ADDENDUM NO. 1

FOR: MIDDLE SCHOOL PARKING LOT IMPROVEMENTS
(LEWIS CENTRAL MIDDLE SCHOOL)

JOB NO. 0124284.01-020

DATE: February 23, 2026

REMOVAL PLAN

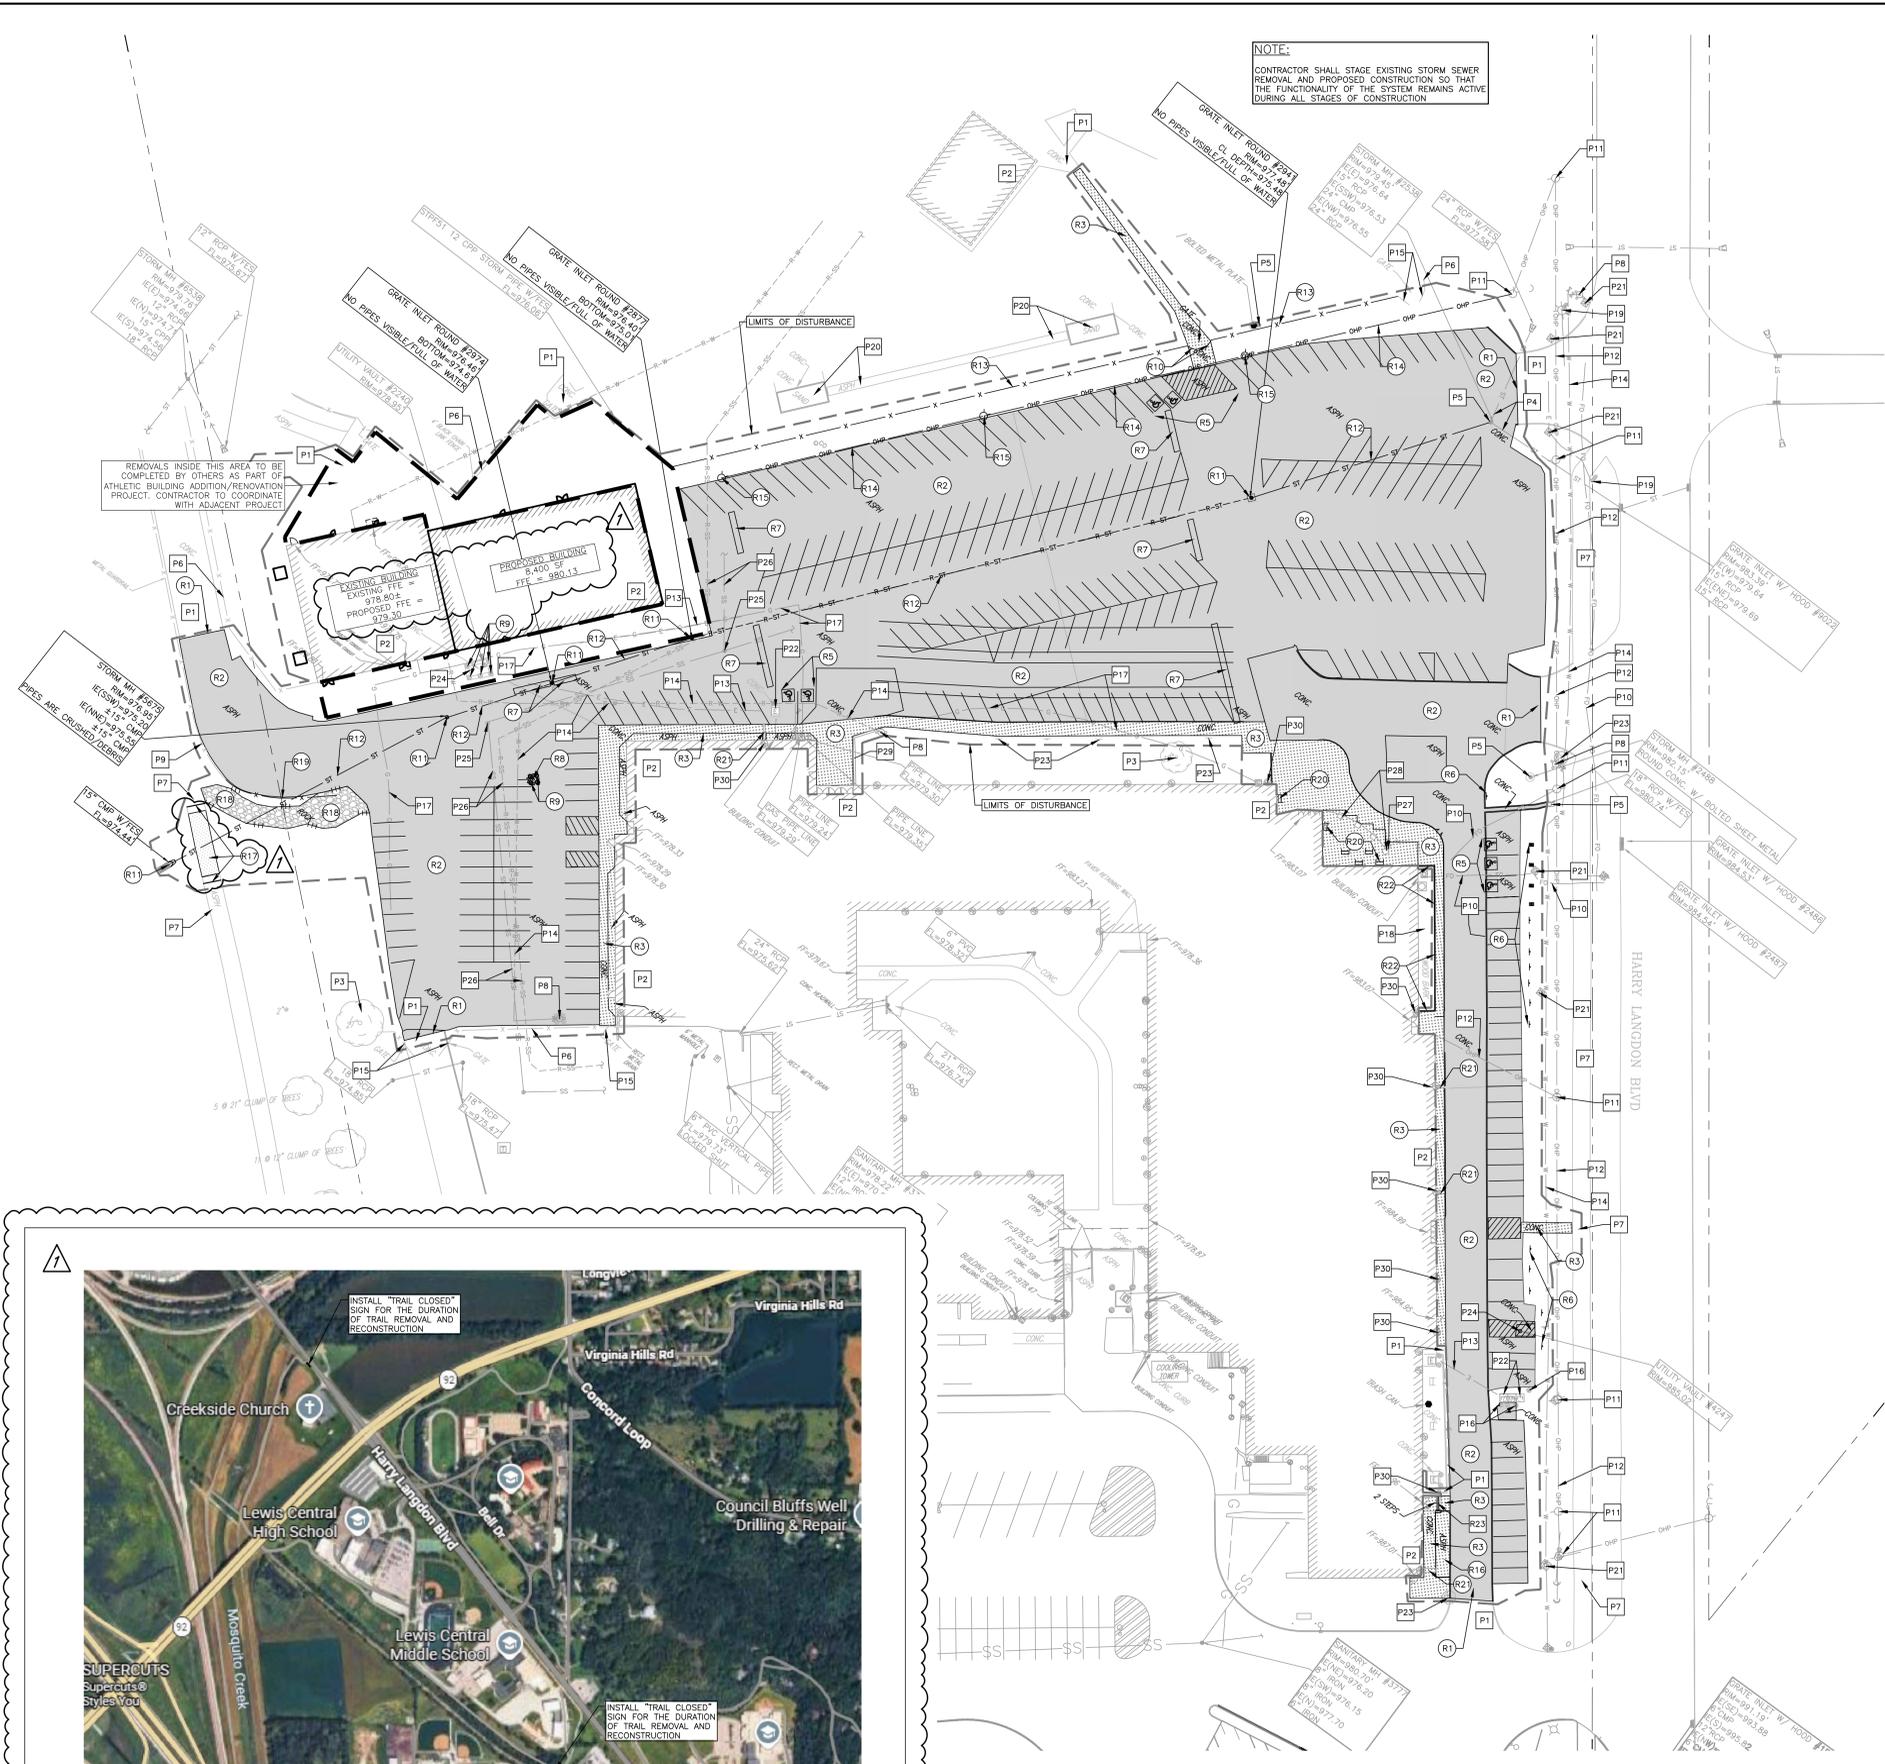
ADDENDUM 1 - 02-23-2026
 - ADDED TRAIL CLOSURE DETAIL
 - UPDATED REMOVAL KEYNOTE 17
 - REVISED LIMITS OF DISTURBANCE

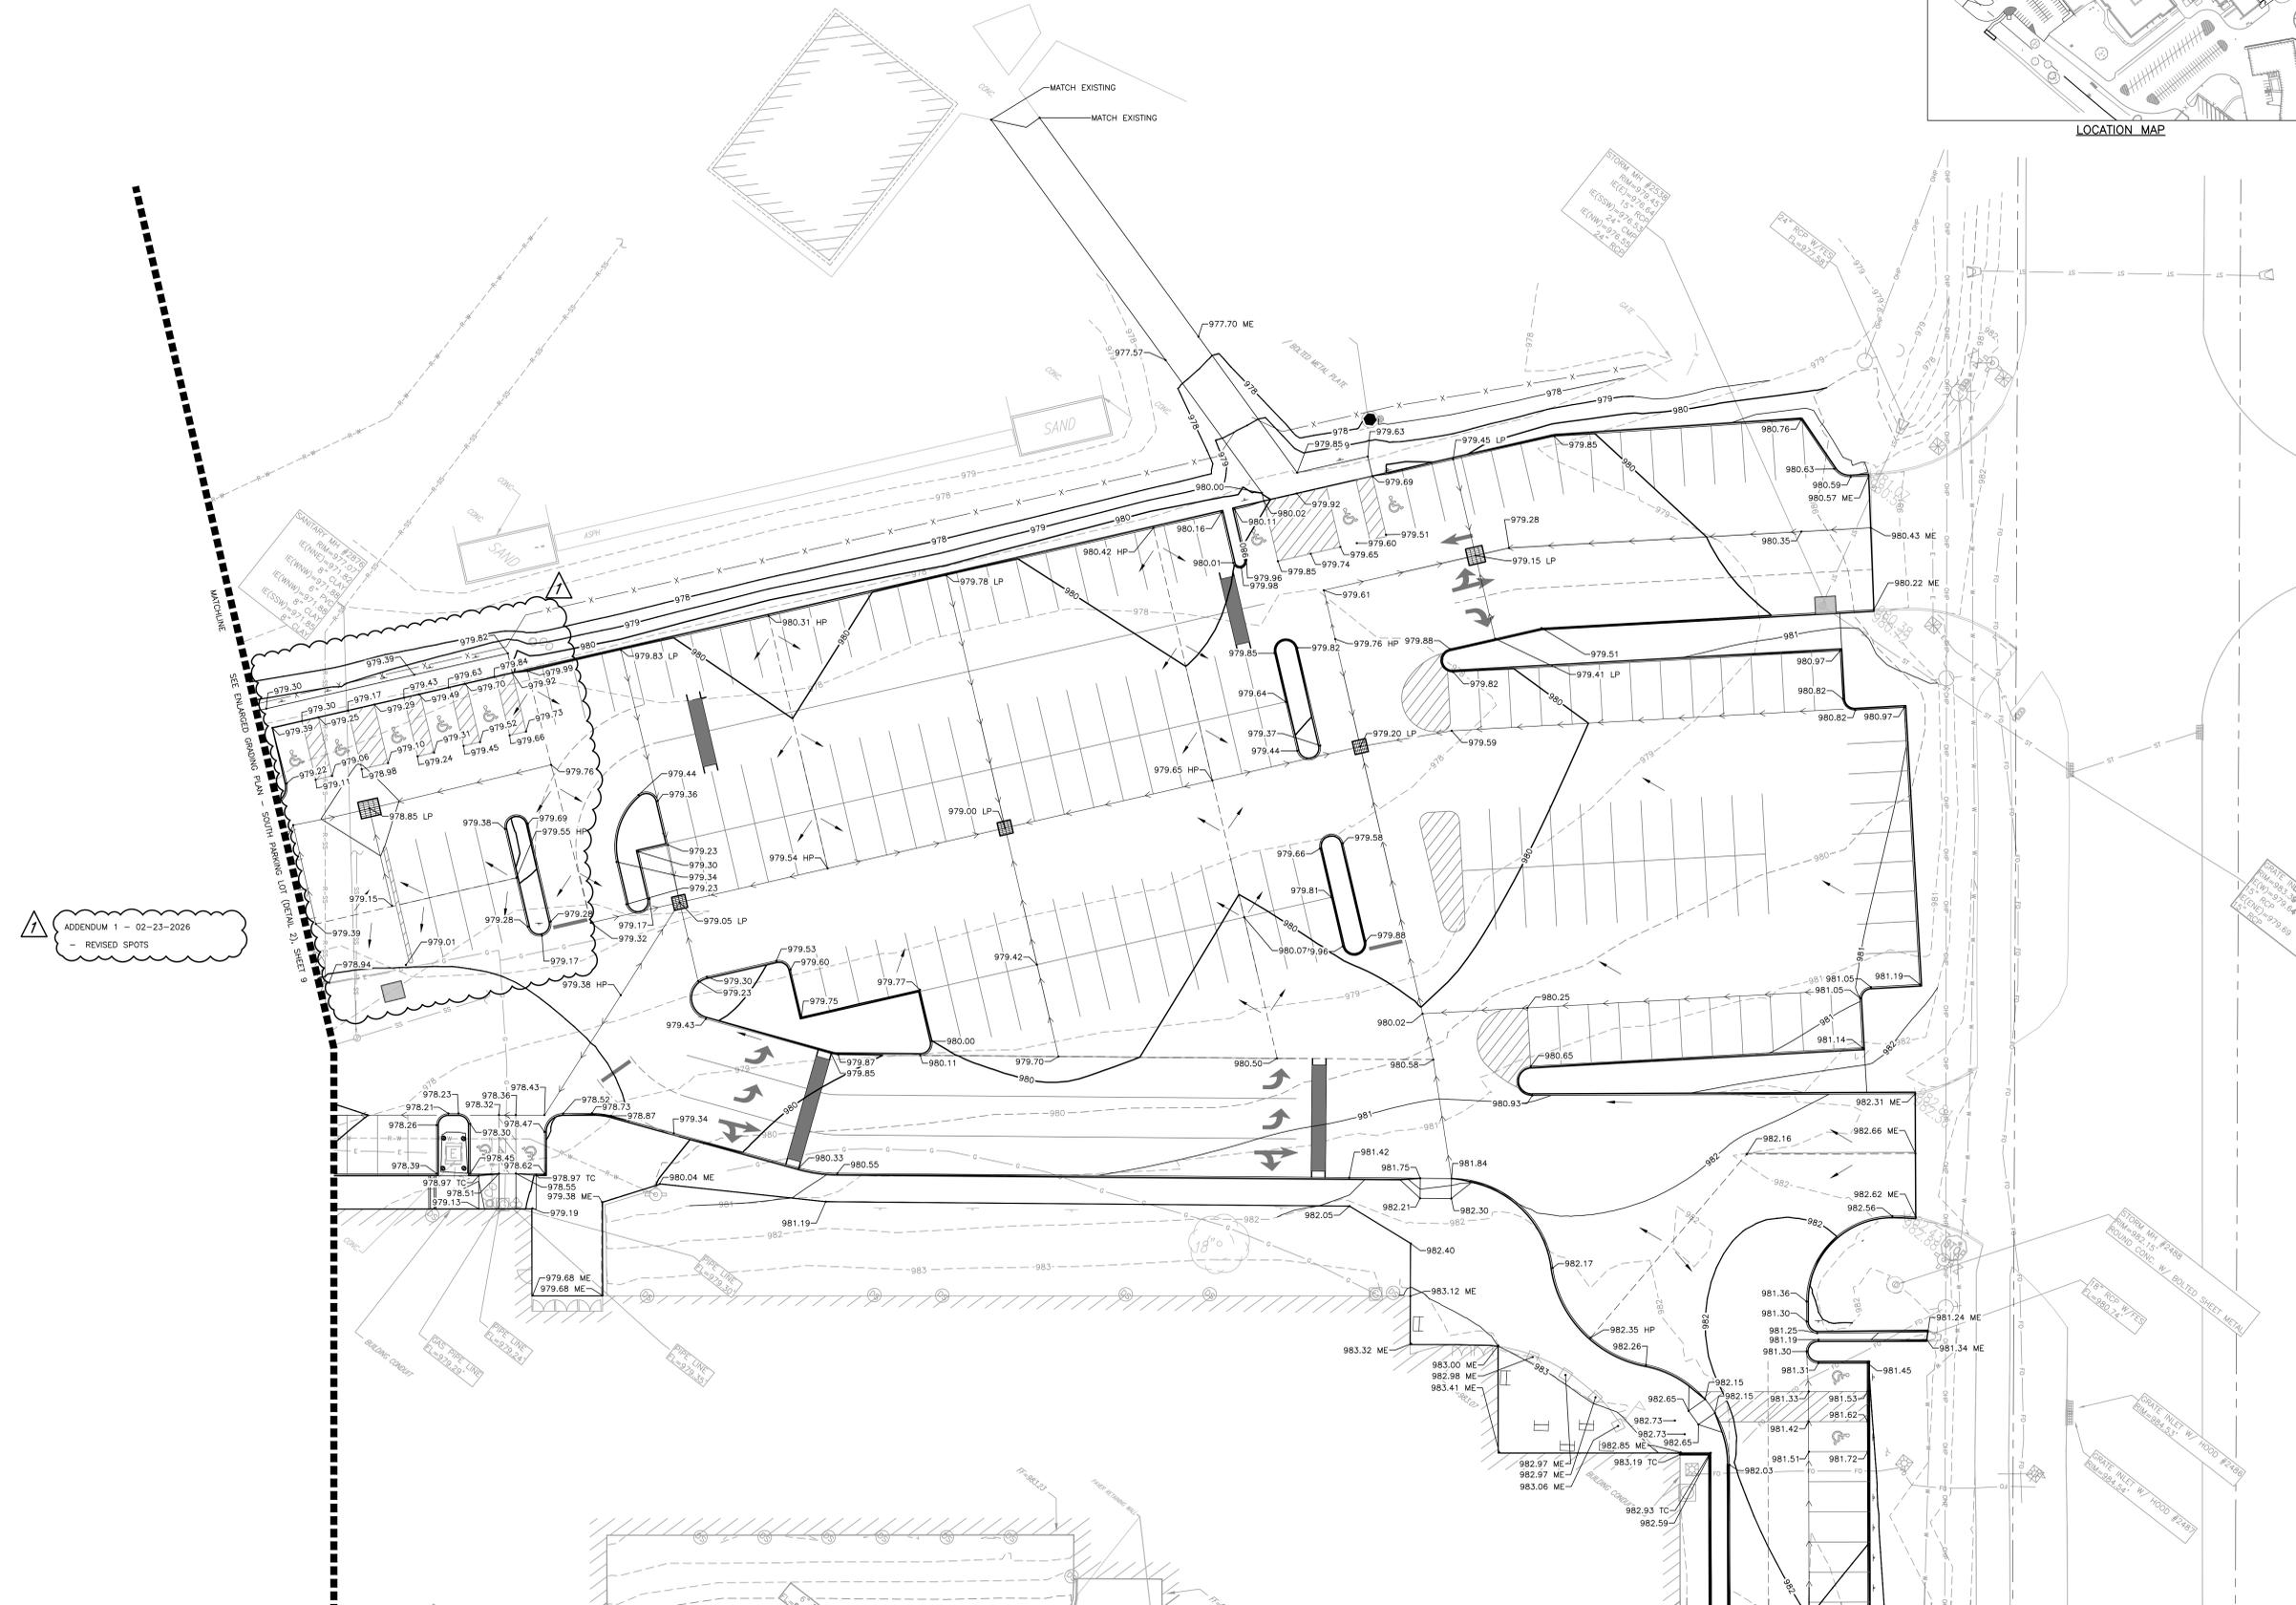
ADDENDUM 1 - 02-23-2026
- REVISED SPOTS

ENLARGED GRADING PLAN-2 OF 2

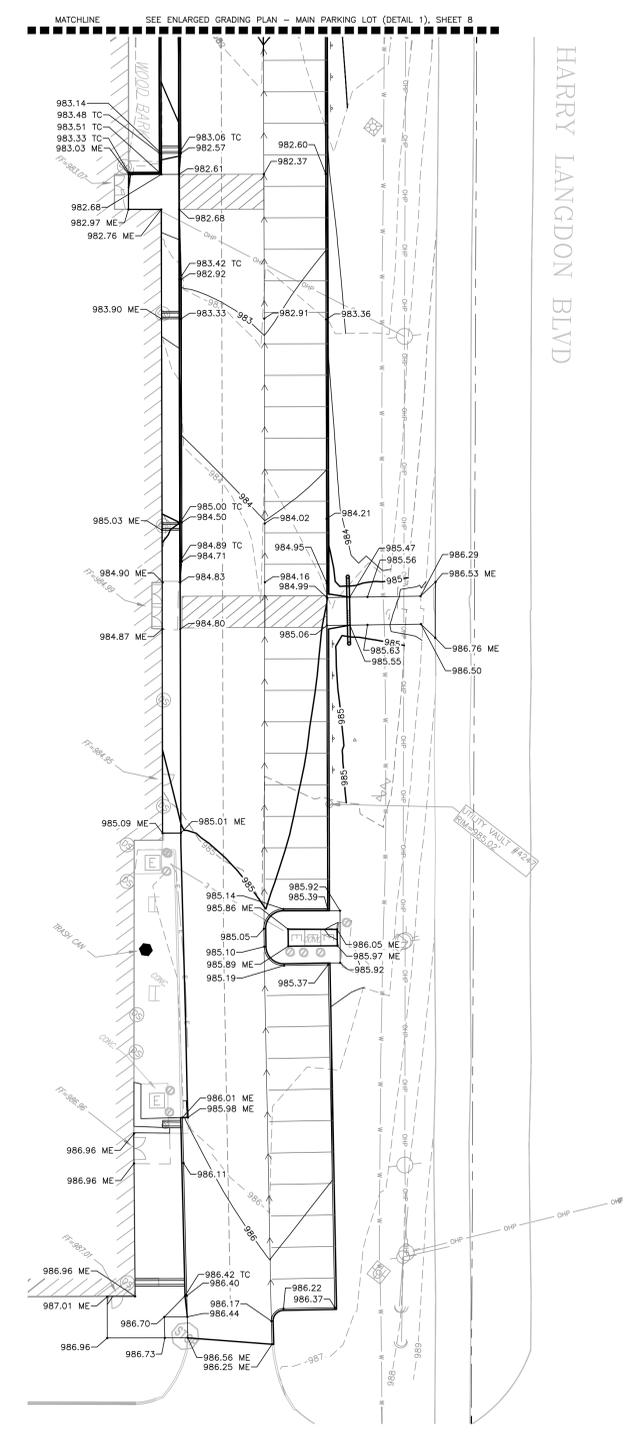
ADDENDUM 1 - 02-23-2026
 - REVISED SPOTS

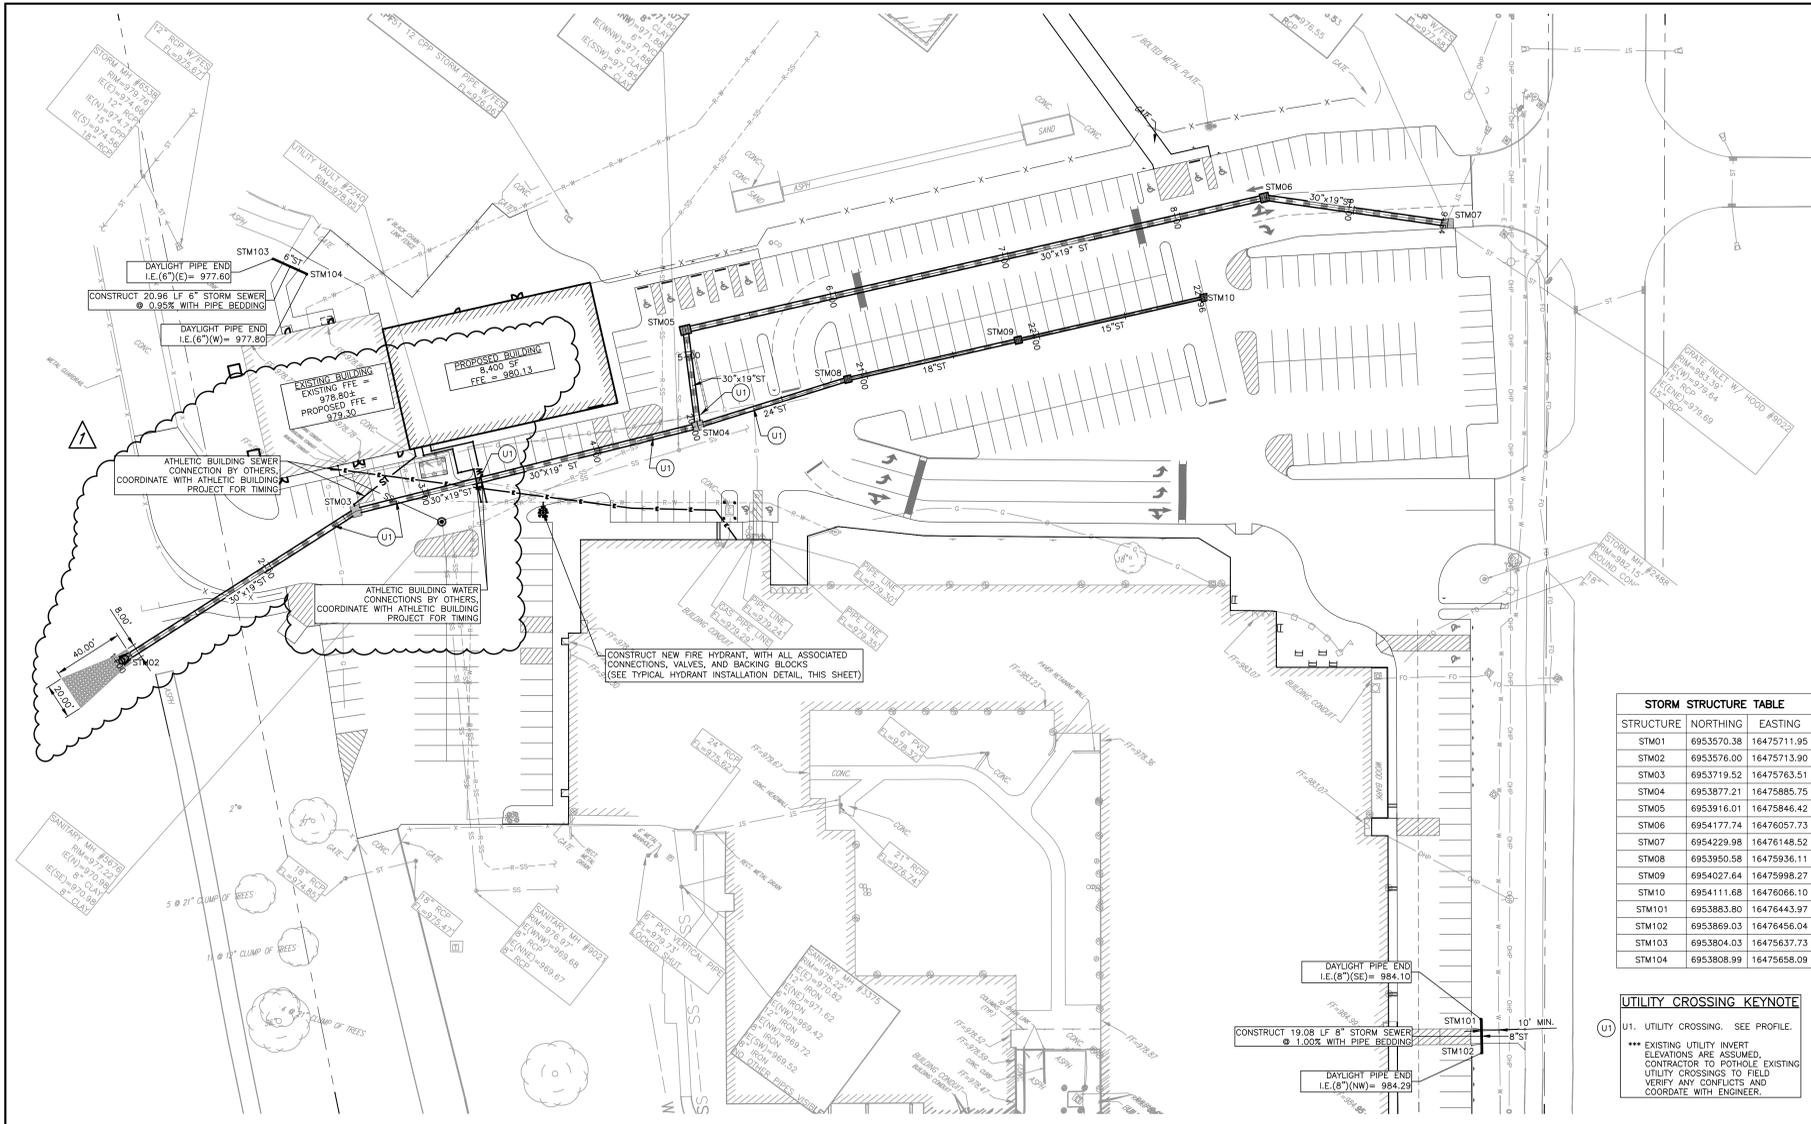
ADDENDUM 1 - 02-23-2026
- REVISED NOTES
